DG2002-4.0-XXP-1Y-01A (H) Product upgrade notification

Date of notification: 24/02/2016

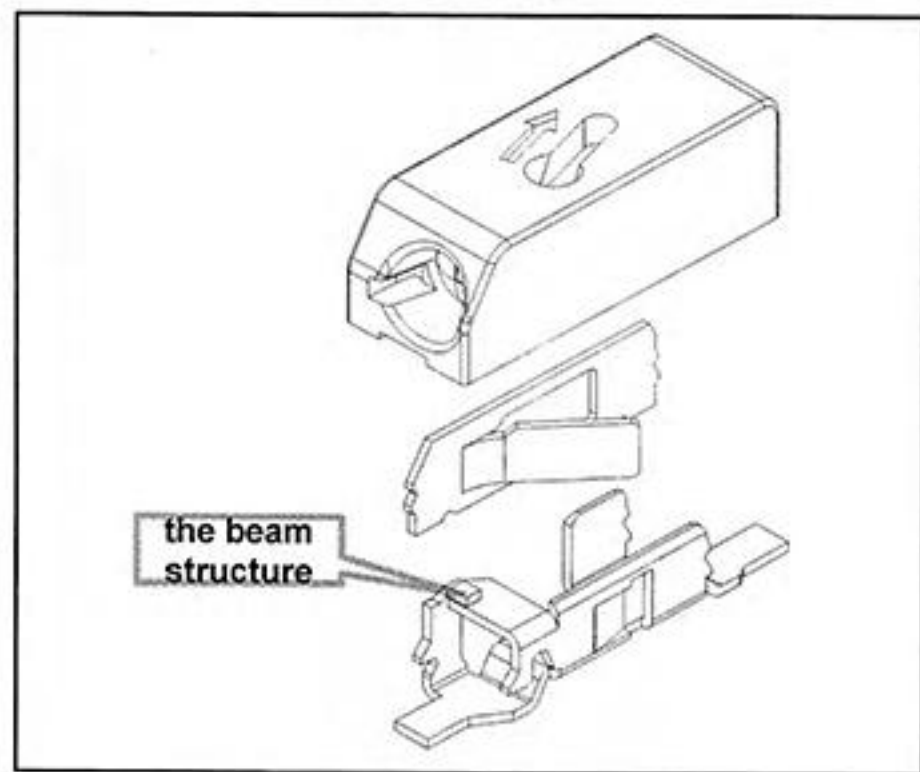
1. Upgrade issues: (1) Pin adds the beam structure to withstand the force of wire, the force is vertical upward with the direction of wiring, it can prevent housing and pin from separating.
(2) Upgraded product name is DG2002-4.0-XXP-1Y-100A(H)

(a) after finishing wiring to the product of existing structure, we apply a force to wire, the force is vertical upward with the direction of wiring, but there is a separation risk between housing and pin when the force is up to 30N (the force of safety standard is 20N), in order to prevent wrong operation which results in abnormal product use, we design a new structure which can prevent the risk.

(b) Take 02P product for example: new structure will ensure the reliability between housing and pin, when the force is over 60N, product is broken and the housing is still together with pin.

(c) New product structure improves mechanical performance of product and also can ensure electric performance.
